## Proposal for Supplement 2 to the 00 and 01 series of amendments of Regulation No. 135 (Pole Side Impact)

## Submitted by the expert from France \*

**Figure**

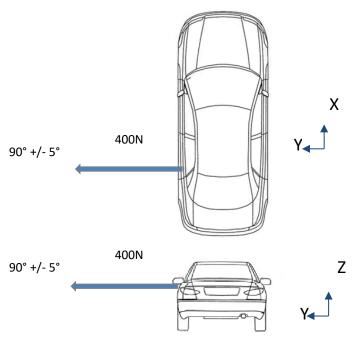
- (a) if it is clearly visible, that the door lock is latched; or
- (b) if the door does not open under a static tractive force of at least 400 N in the y-direction applied to the door, according to the Figure below, as close as possible to the window sill and to the edge of the door opposite to the hinged side, except to the door handle itself.
